Illinois Tollway Standard Drawing Revisions

Section H		Roadway Lighting	
Drawing	Modification Summary	Effective: 03-01-2026	
H1-14	LIGHT STANDARD FOUNDATION		
Sheet 1	Alternate anchor bolt detail added.

**LIGHT STANDARD FOUNDATION DETAILS - HELIX
(GROUND MOUNTED UNITS)**

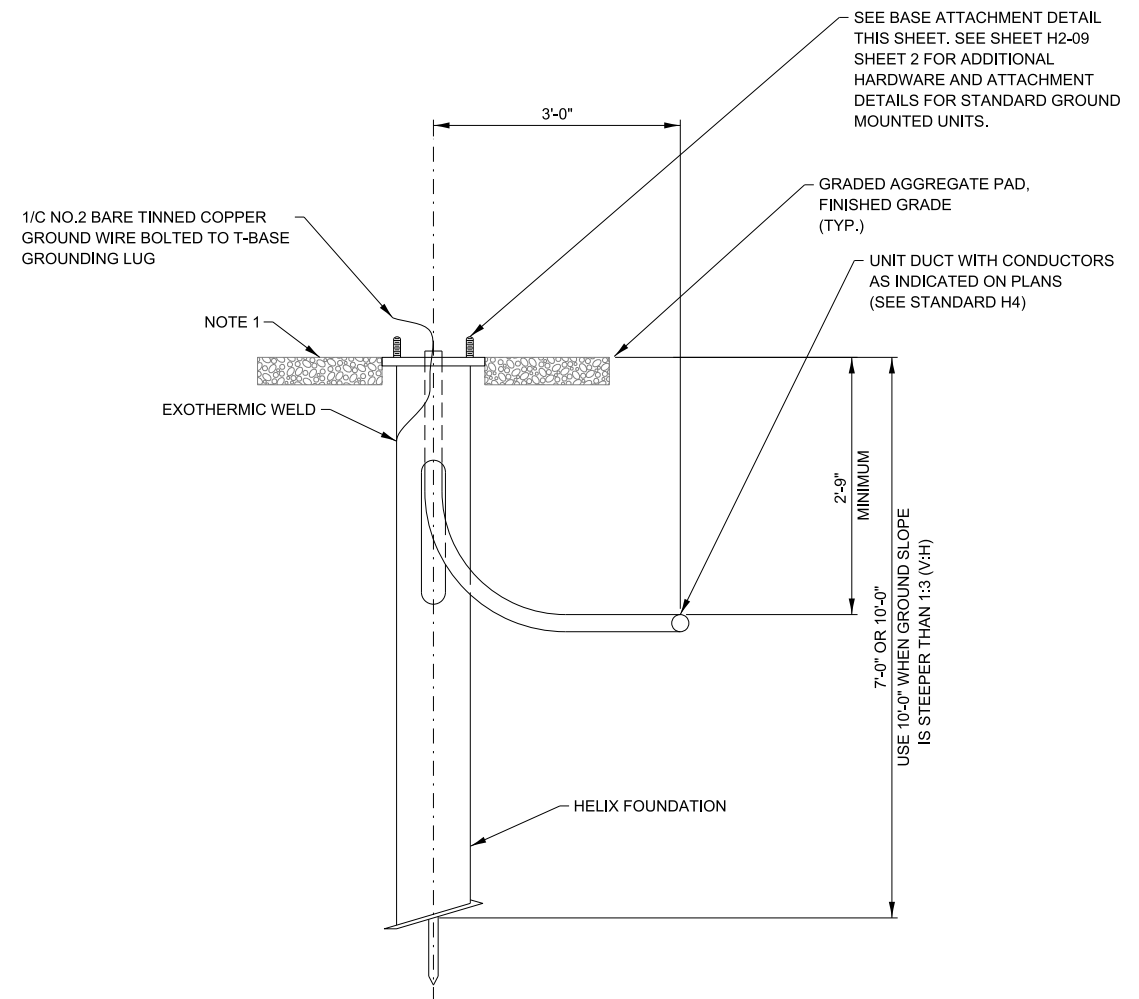
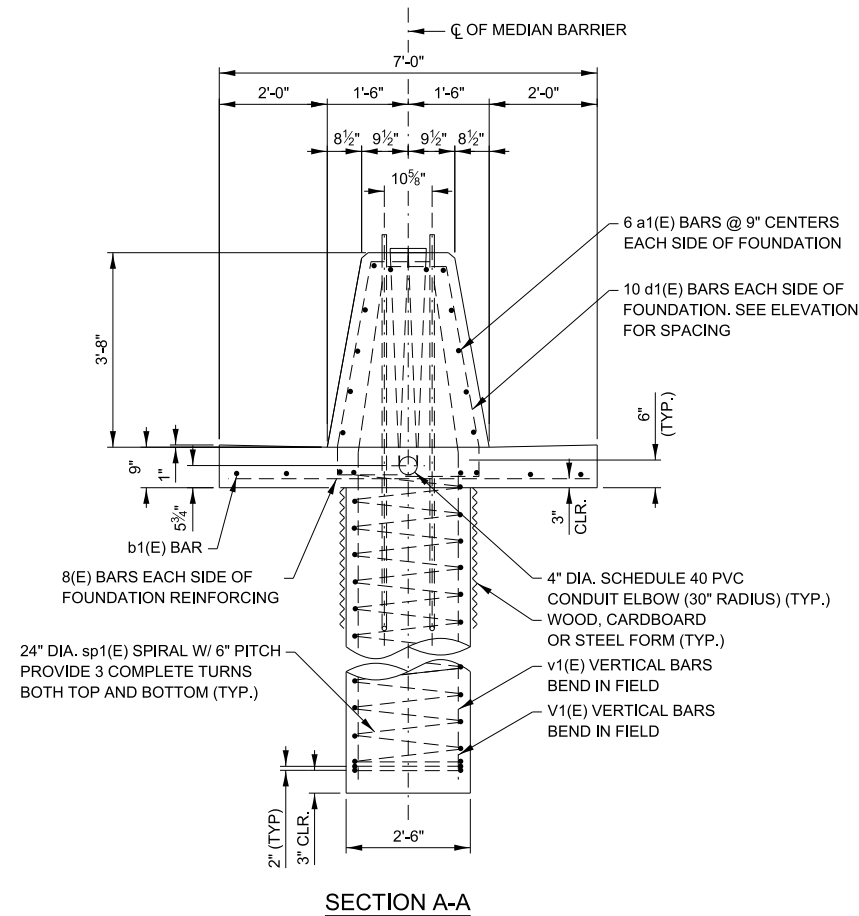
Sheet 2	Drilled holes diameter revised to 1 1/8" and Center hole diameter revised to 10 13/16" in Isometric View		
Sheet 3	Alternate anchor bolt detail added.

LIGHT STANDARD DETAILS

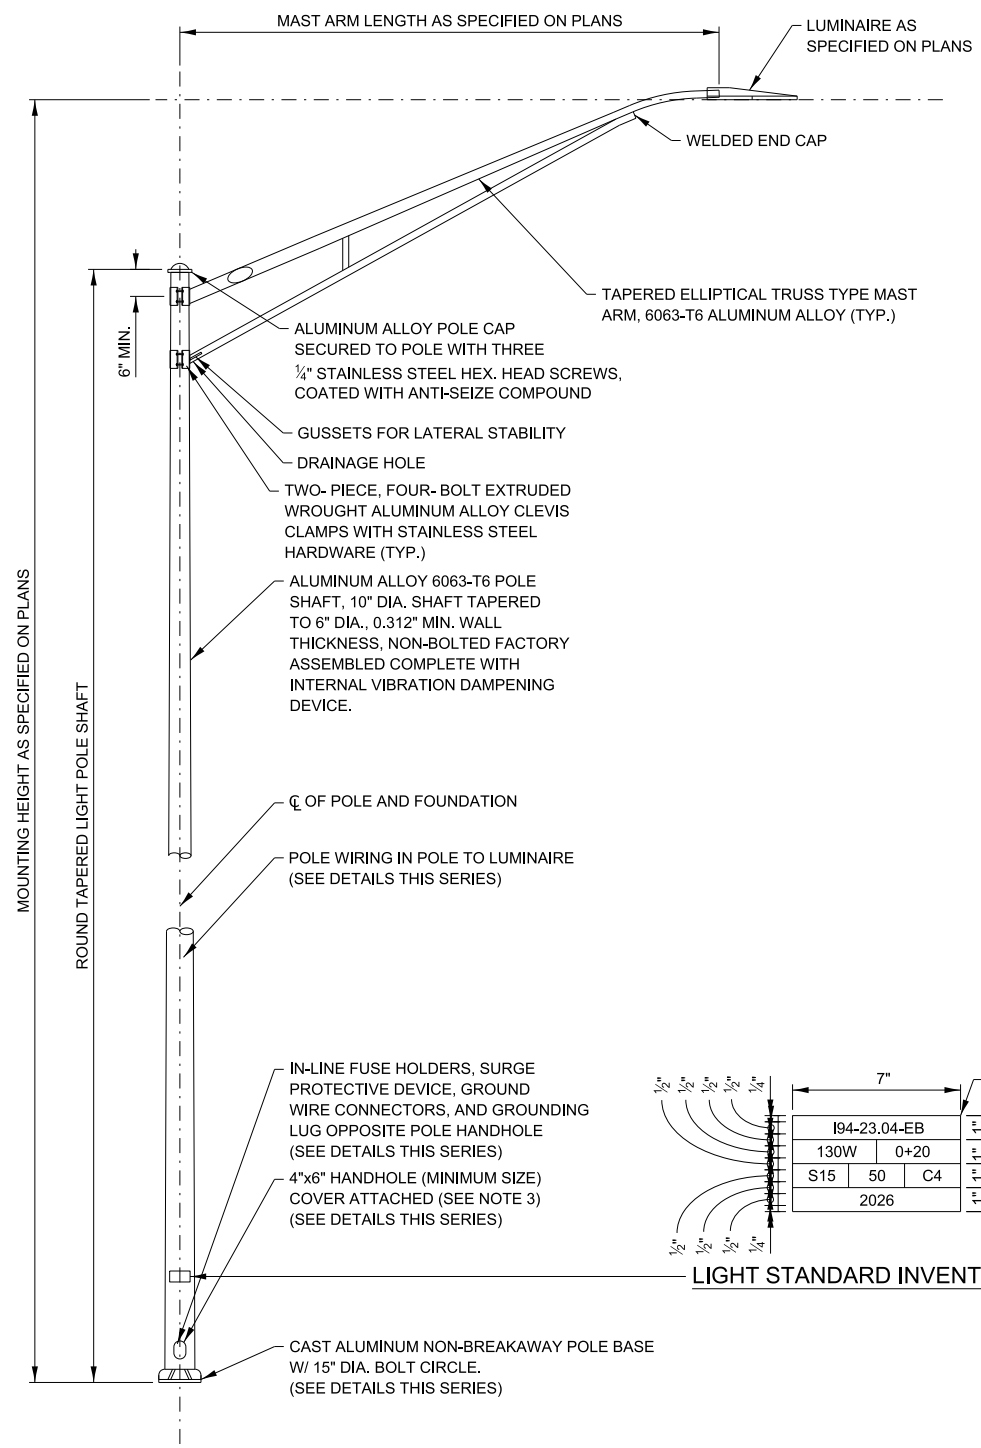
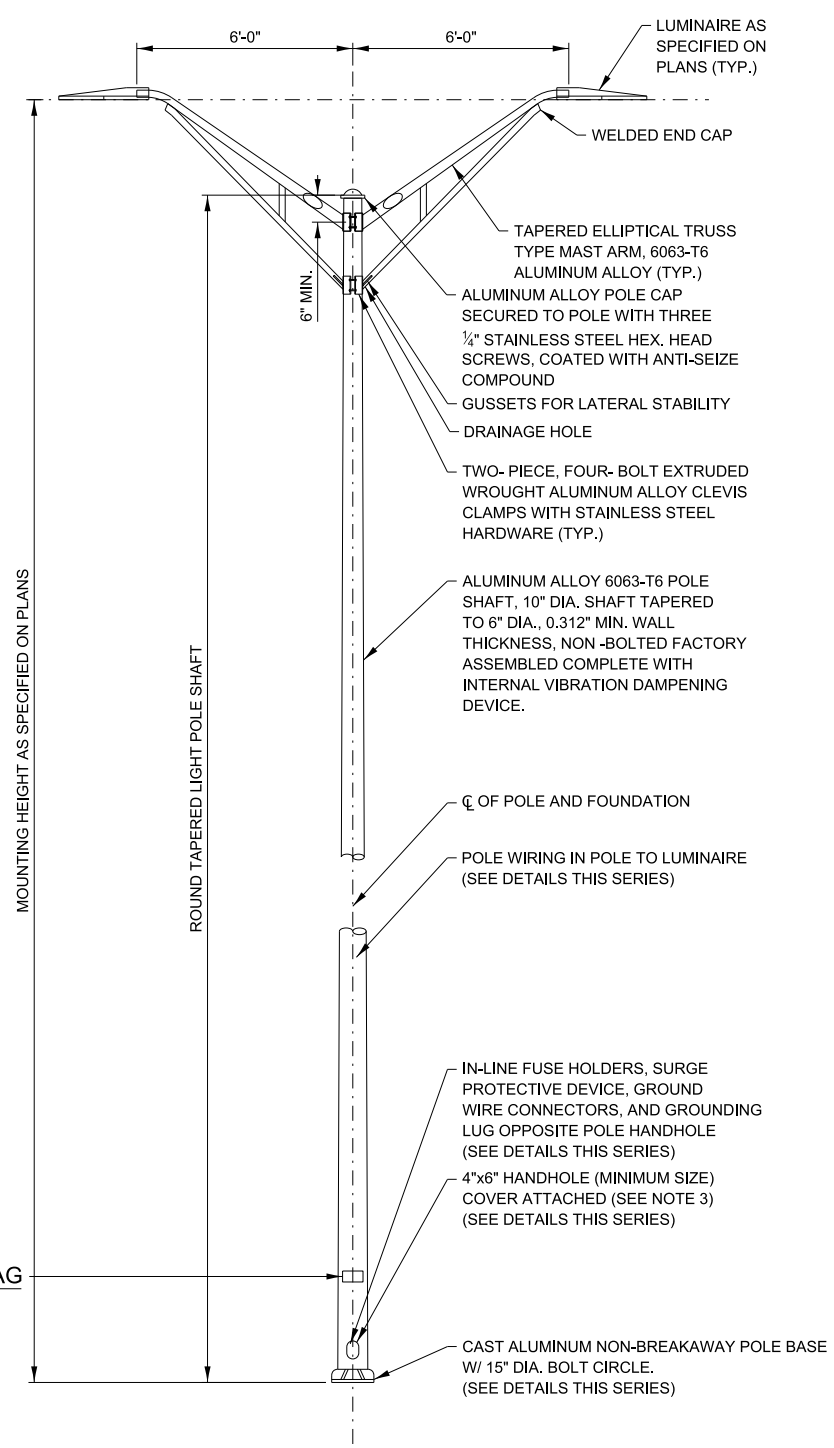
Sheet 10	Alternate anchor bolt detail added.		
H2-11	LIGHT STANDARD DETAILS		
Sheet 1	Replaced "TWIN" mast arm with "DUAL" mast arm in the light standard detail. Added a new detail and note addressing the nomenclature for labeling a light standard .

REVISIONS	
DATE	DESCRIPTION
03-01-2026	REPLACED "TWIN" MAST ARM WITH "DUAL" MAST ARM. ADDED NOMENCLATURE FOR LABELING A LIGHT STANDARD, REPLACED THE #6 BARE COPPER CONDUCTOR WITH #10 INSULATED CONDUCTOR.

LIGHT STANDARD WIRING DETAILS

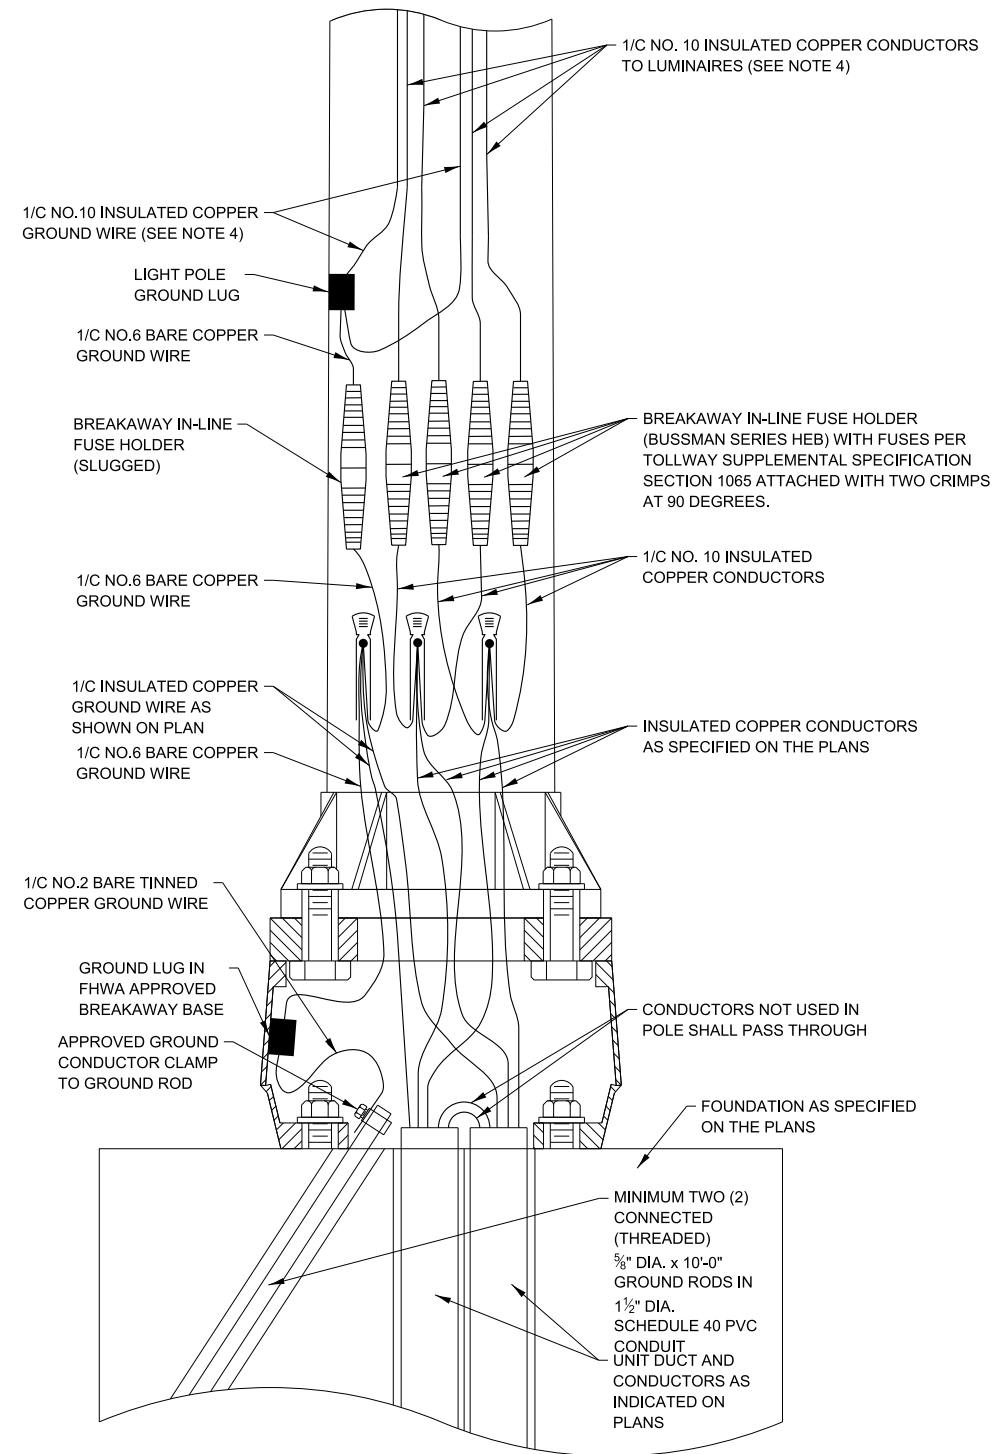
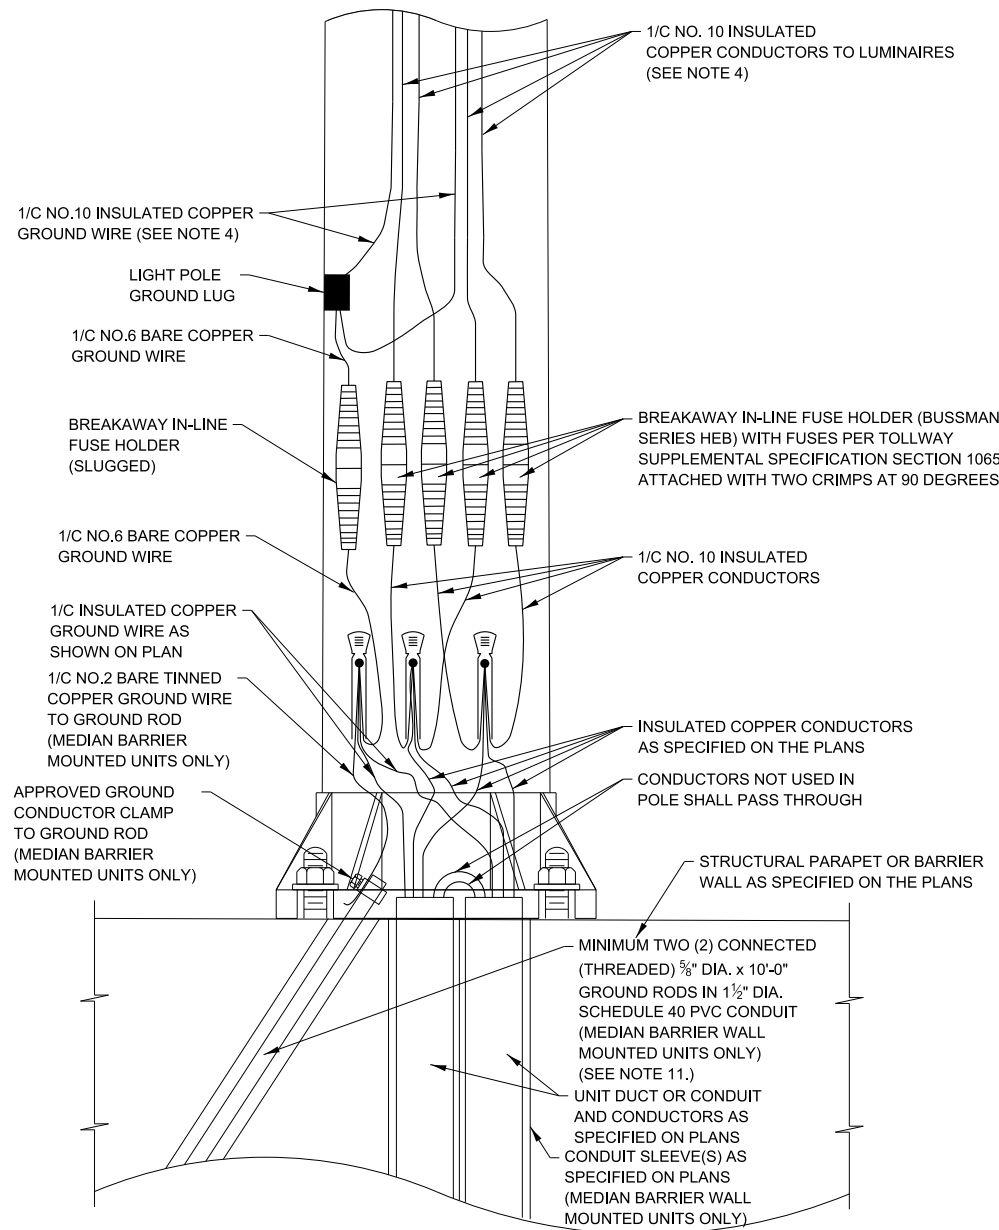
Sheet 3	Revised the #6 bare copper ground wire from the ground lug to the fixture to a #10 insulated ground wire.		
H5-07	SERVICE POLE AND PEDESTAL DETAILS

SERVICE POLE AND PEDESTAL DETAILS

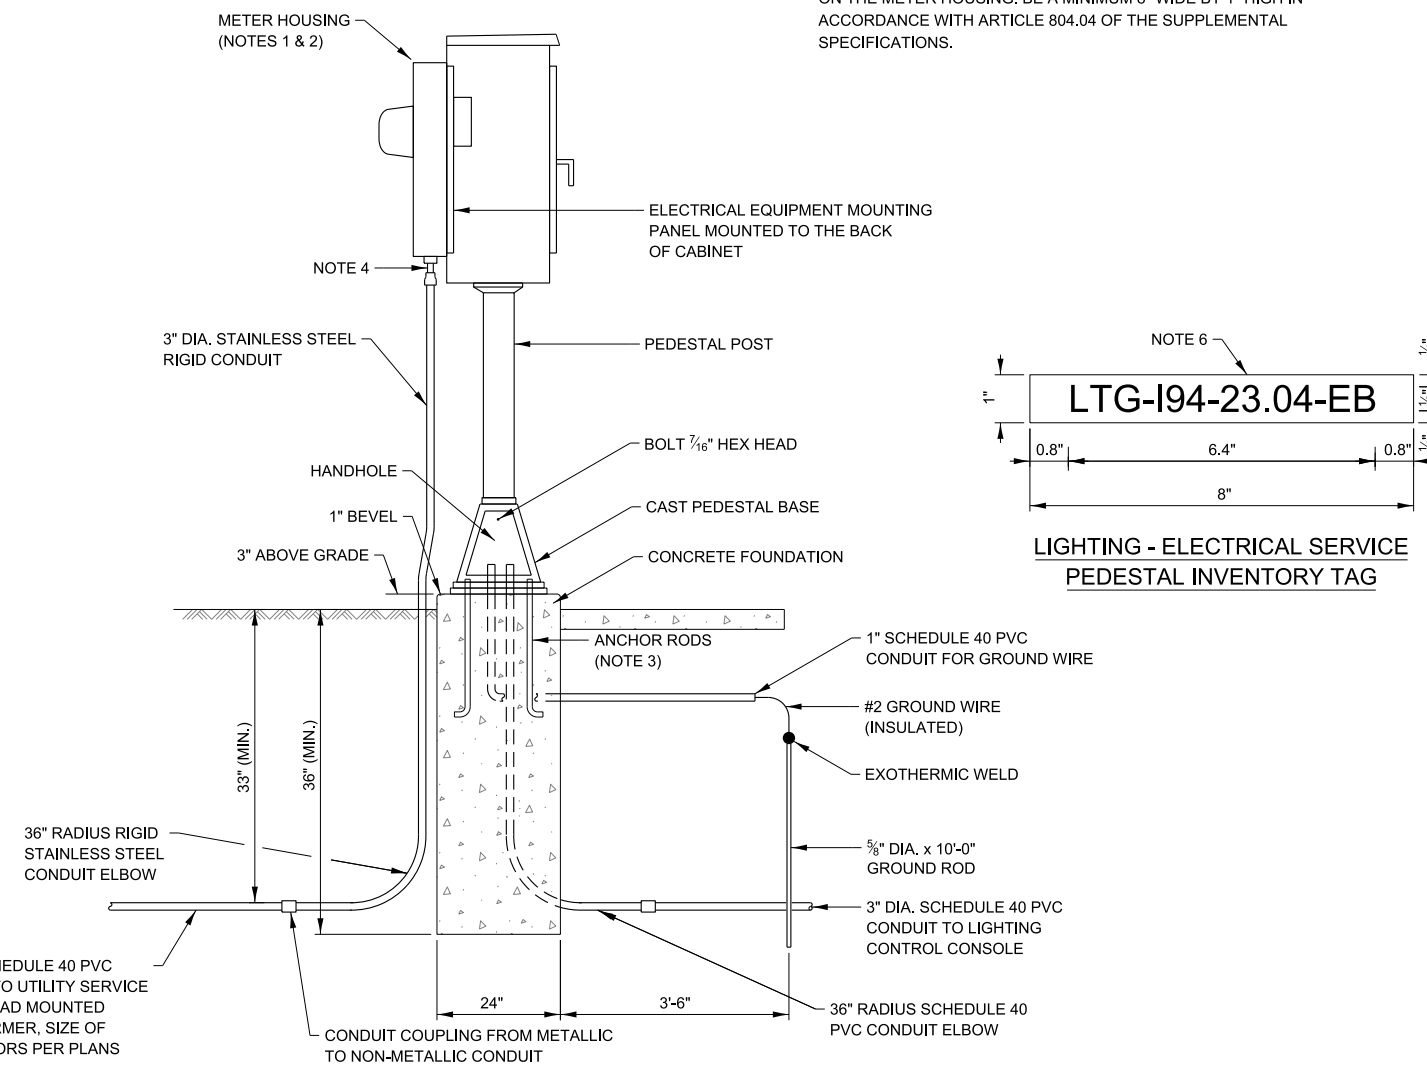
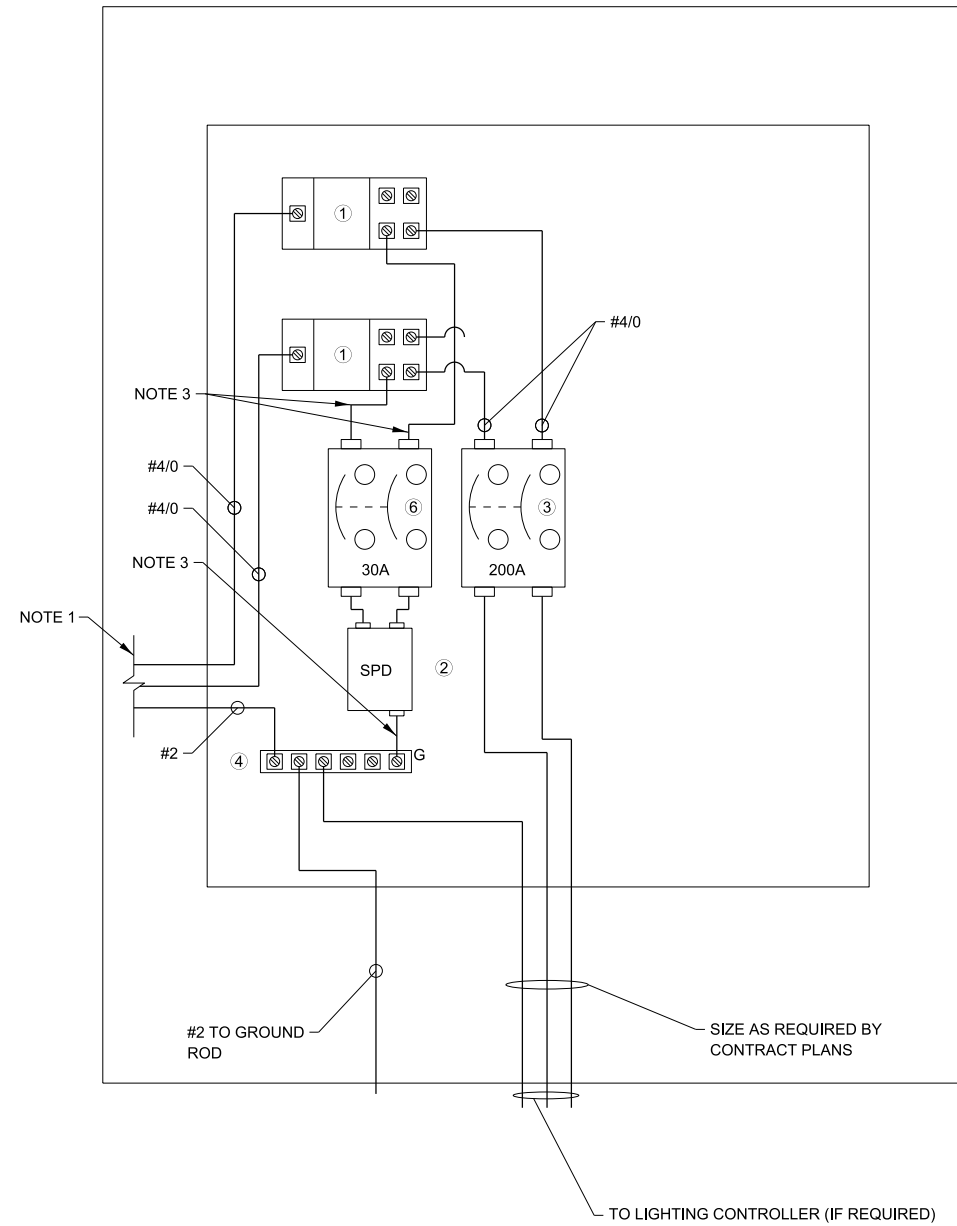
Sheet 1	Added a new detail and note addressing the nomenclature for labeling an electrical service pedestal.		
H6-07	EXTERIOR CONTROL CONSOLE DETAILS		
Sheet 1	Added a new detail and note addressing the nomenclature for labeling an exterior control console.		
H7-05	EXTERIOR CONTROL CONSOLE FOUNDATION DETAILS

REVISIONS	
DATE	DESCRIPTION
03-01-2026	ADDED NOMENCLATURE FOR LABELING
03-01-2021	AN ELECTRIC SERVICE PEDESTAL. ADDED COMBINED LIGHTING/ITS PEDESTAL.
03-01-2018	TYPOGRAPHICAL CORRECTIONS.
03-31-2017	ADDED EQUIPMENT LAYOUTS.
